Entergy Nuclear Operations, Inc.
Pilgrim Nuclear Power Station
600 Rocky Hill Road
Plymouth, MA 02360

Entergy Response to NRC Request for Additional Information (RAI),
Pilgrim Proposed License Amendment Request to Modify Technical
Specification 4.3.4, "Heavy Loads" to Facilitate Dry Storage Handling
Operations

LETTER NO: 2.14.048

SAFE LOAD PATH

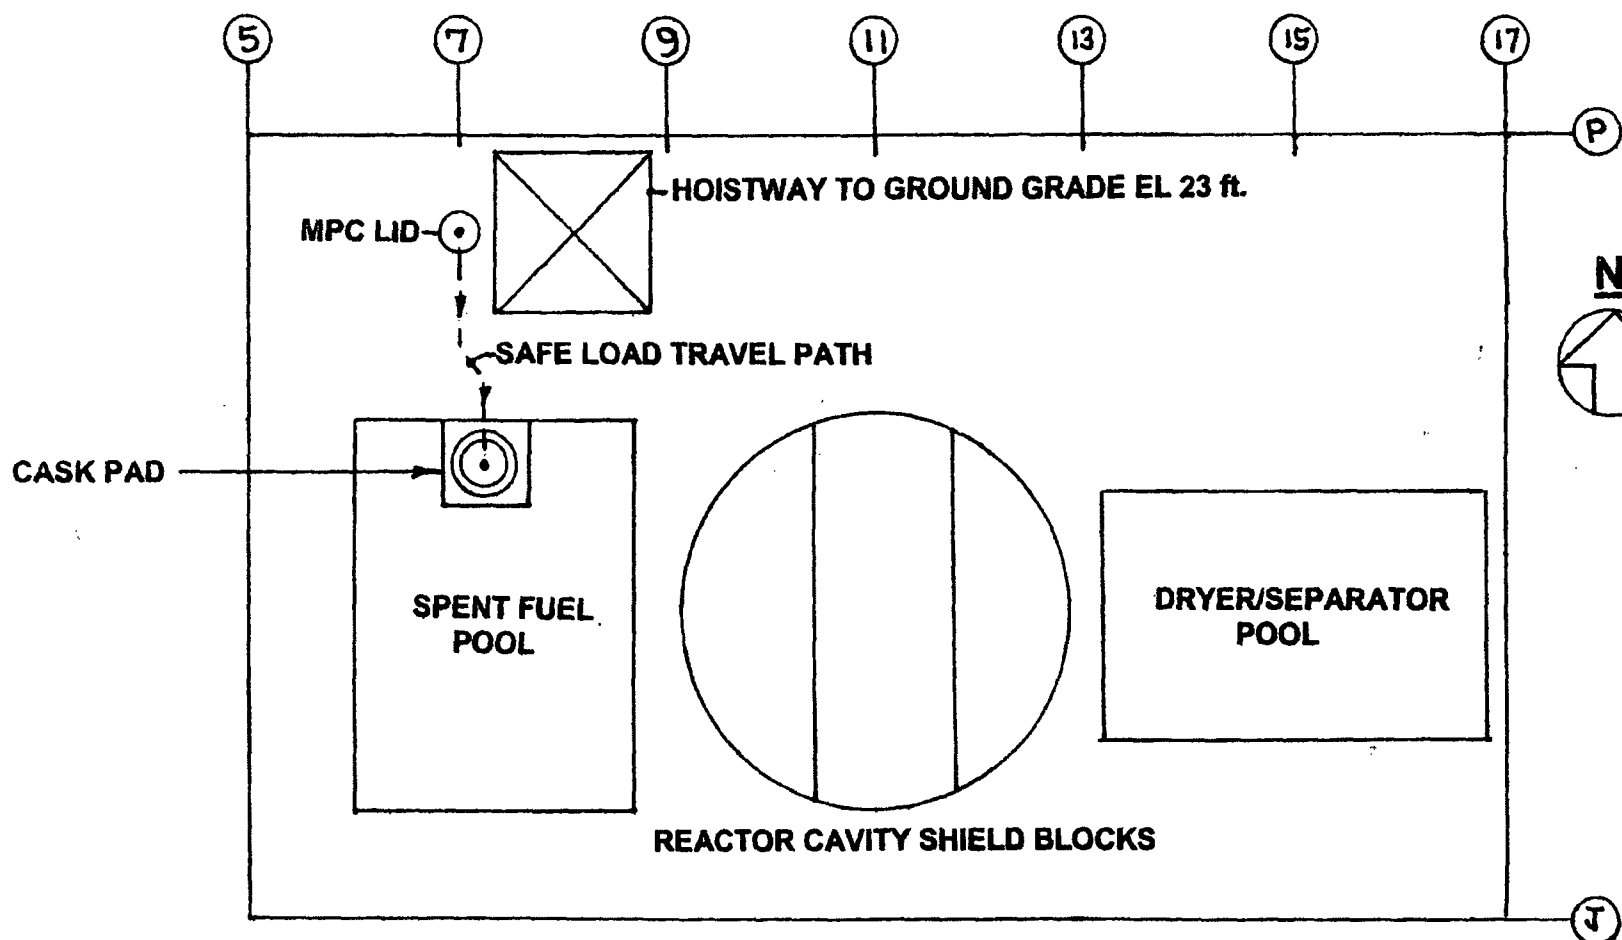
Please provide a simple sketch of the layout showing the arrangements for the Safe Load Path as per NUREG-0612.

The Safe Load Path is shown on Attachment 2 "Safe Load Path" of the Letter. The proposed Safe Load Path meets the NUREG-0612 guidance.
